ADDENDUM No.1
To
Bidding Documents for:

TOWN OF WAREHAM, MA
WANKINQUOAH AVENUE SEWER REPAIR
Contract 2023-002

ATTACHMENT 2

TITLE: TOWN OF WAREHAM, MASSACHUSETTS
WANKINQUOAH AVENUE SEWER REPAIR
CIVIL DETAILS 3

BETA JOB NO. 10914
ISSUE DATE: NOVEMBER 21, 2023
SHEET NO. CD-3

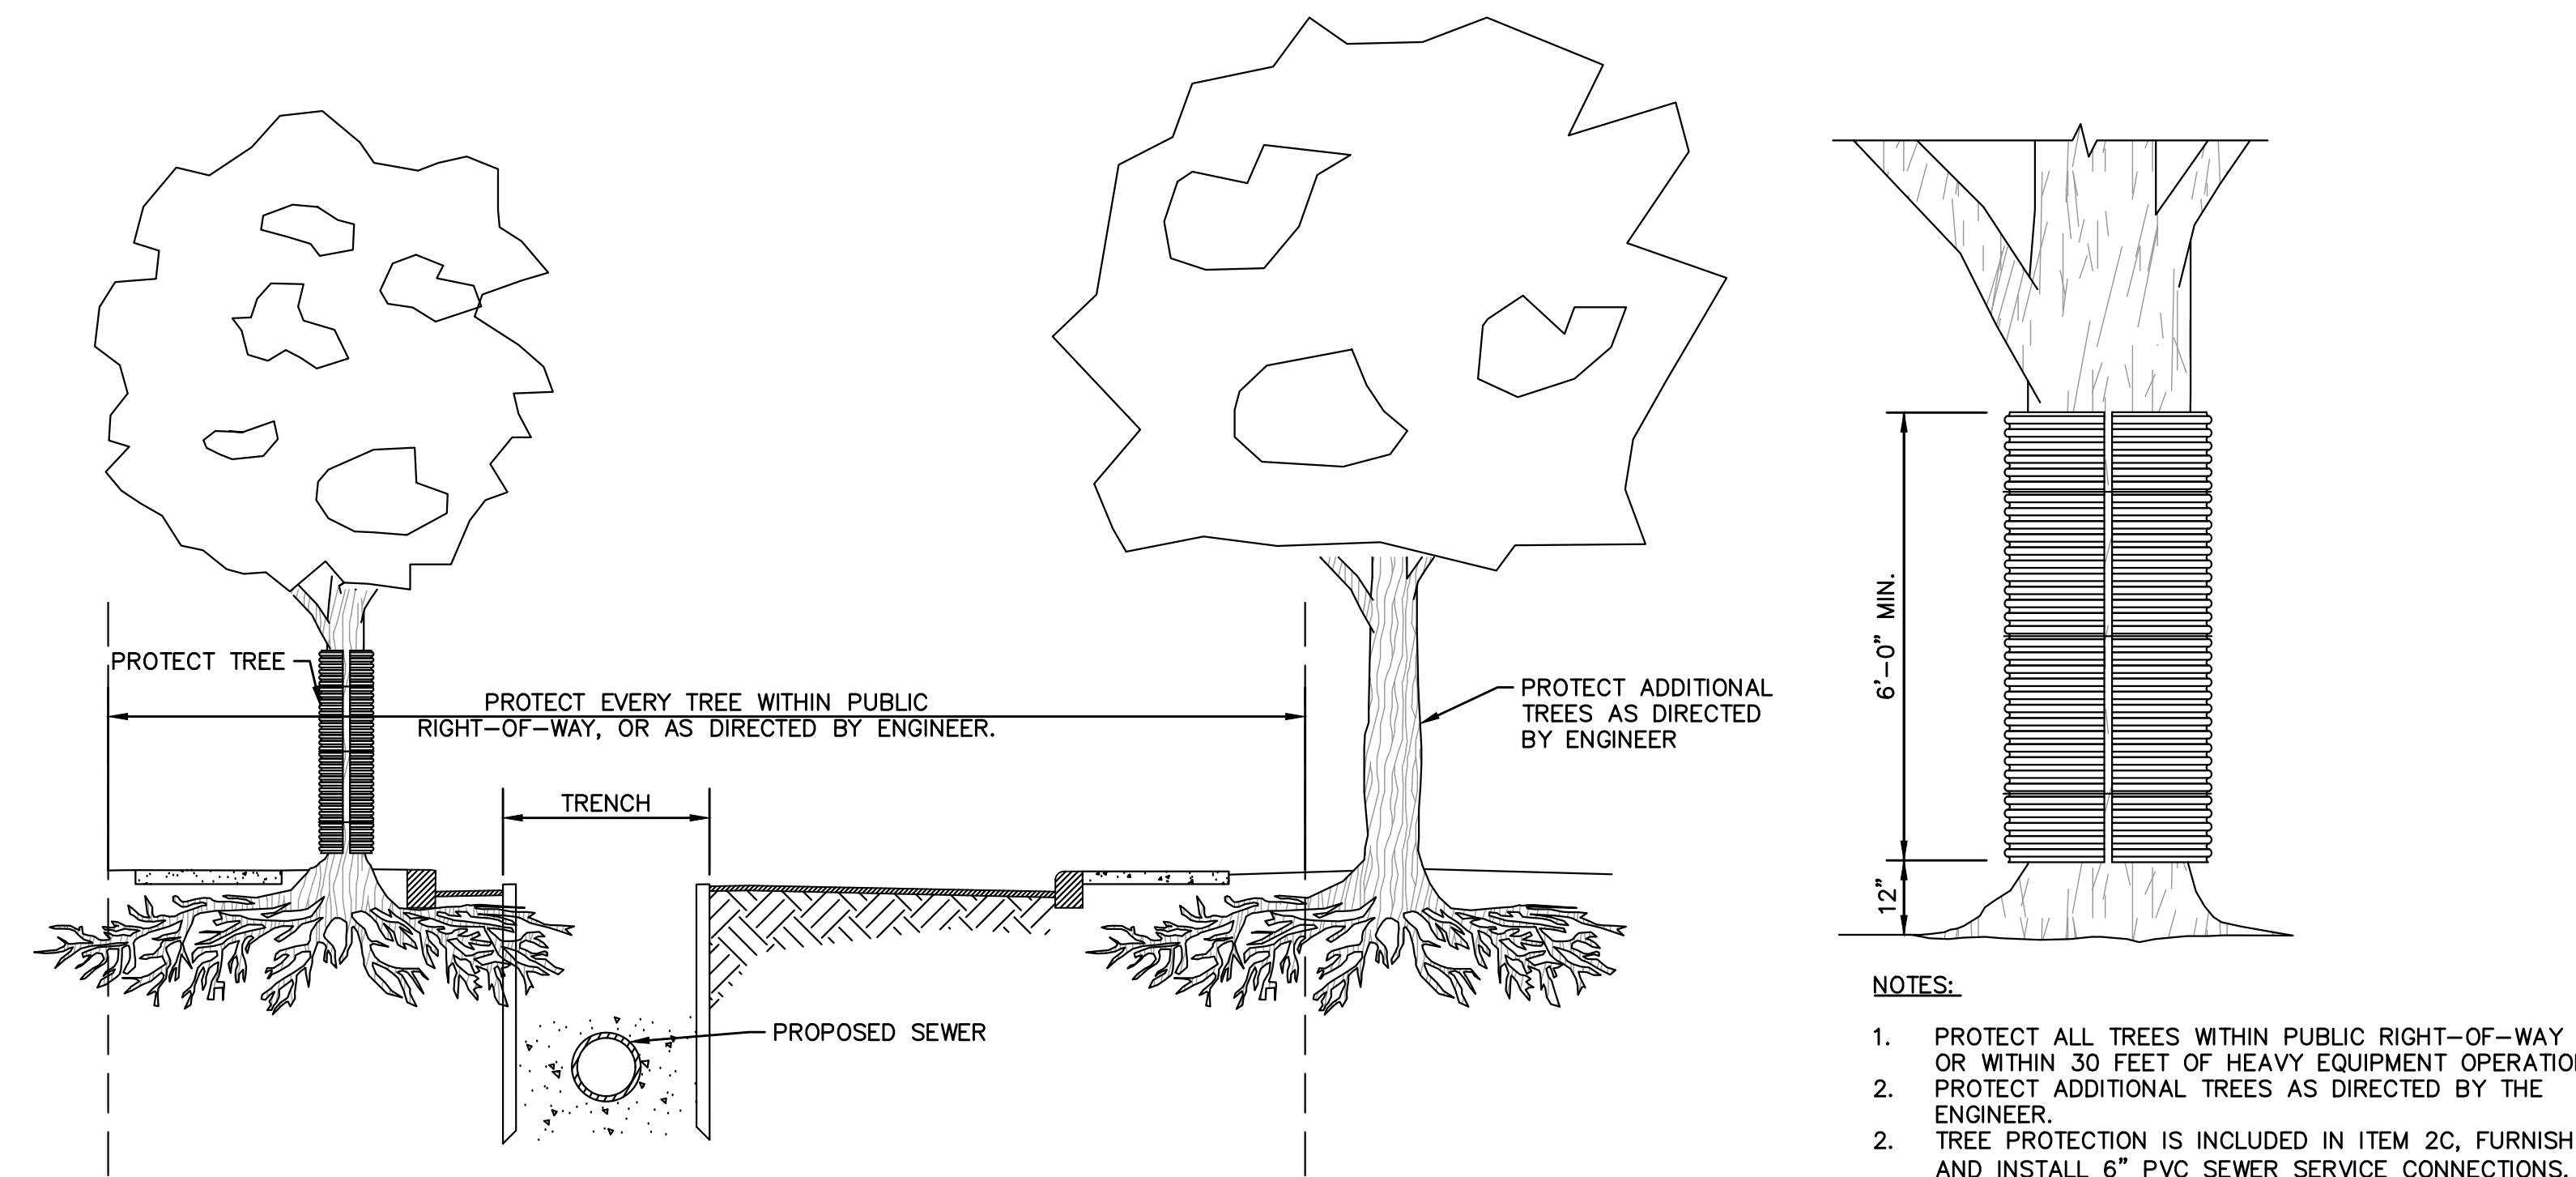
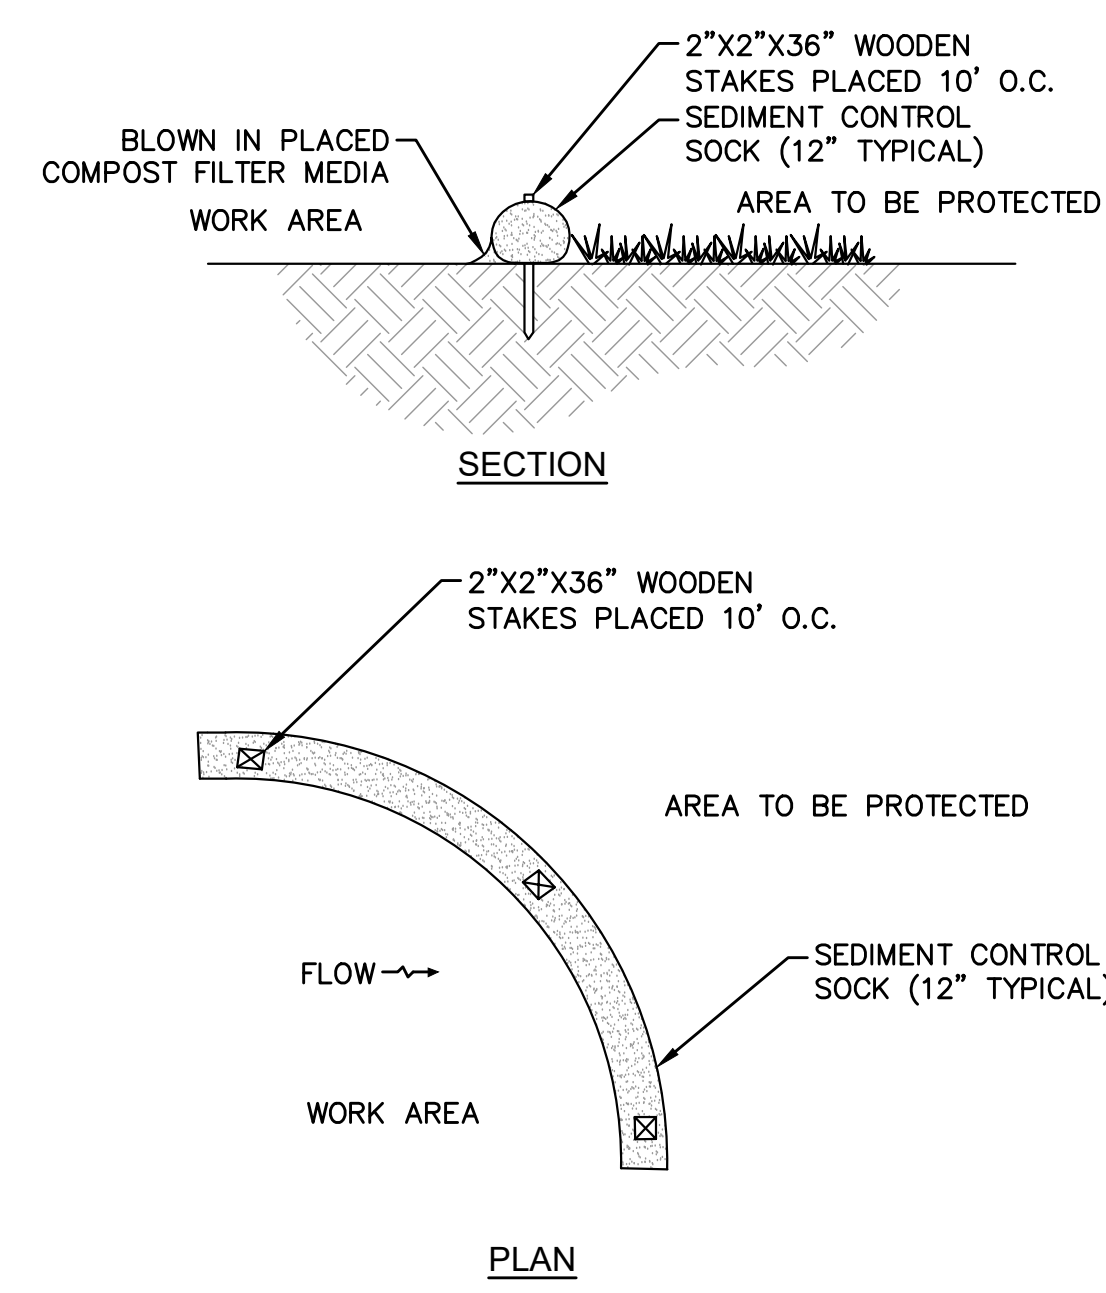
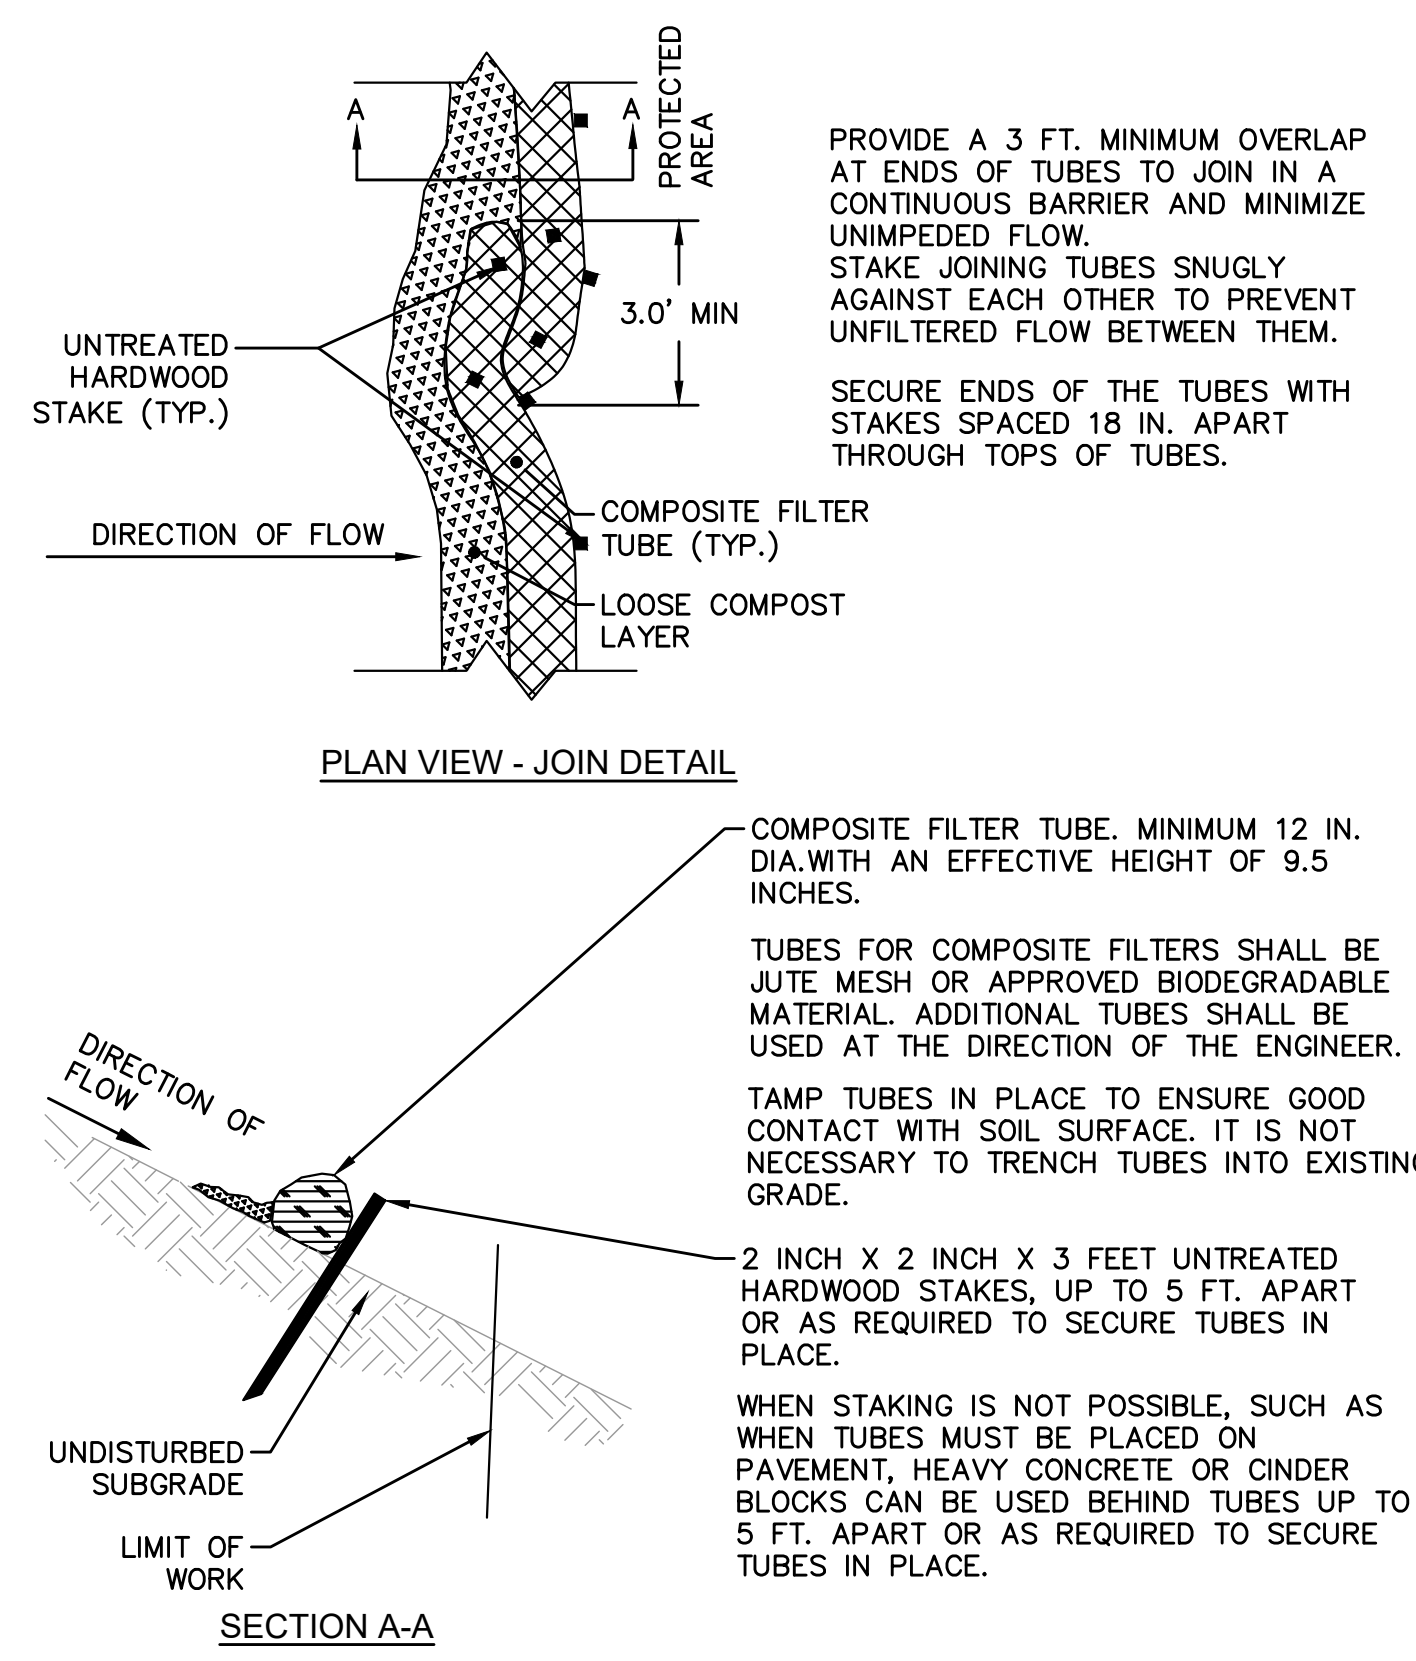
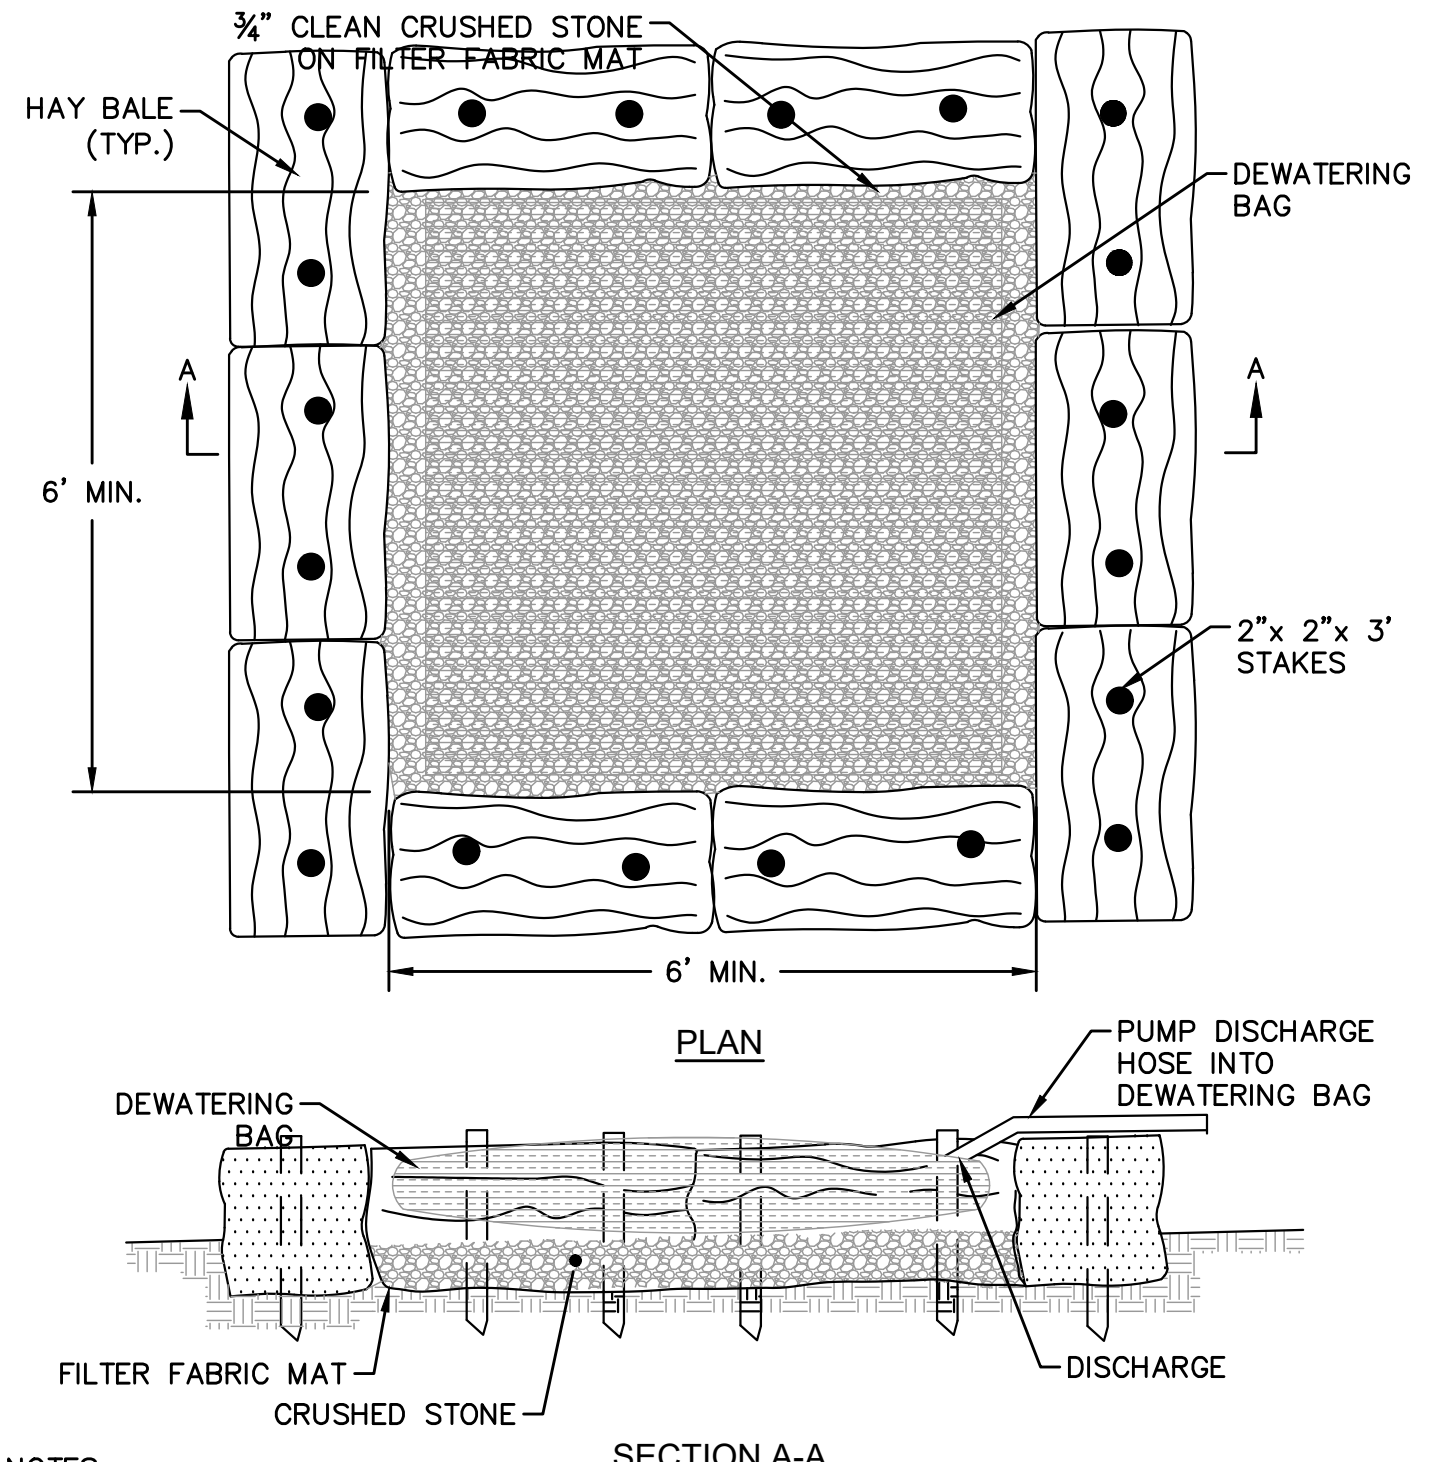
4. The unit price shall also include sleeving of services where services are within 18-inches vertically of the water main. The length of the sleeve shall be paid for under this Item measured by the linear foot.
5. The unit price shall also include replacement of any disturbed driveway aprons and walkway aprons composed of concrete or cobblestone. Bituminous driveway aprons and walkway aprons shall be paid for under Item 12B.
6. Removal and disposal of existing asbestos cement service piping shall be paid for under Item 3.
7. The unit price shall also include tree protection as shown on Sheet CD-3 of the Contract Documents.
8. The unit price shall also include the abandonment of existing sewer service chimneys as shown on Sheet CD-3 of the Contract Documents.

1. **Sheets Revised: Civil Details 3 [CD-3] (See Attachment 2, specific changes in red bubble clouds)**
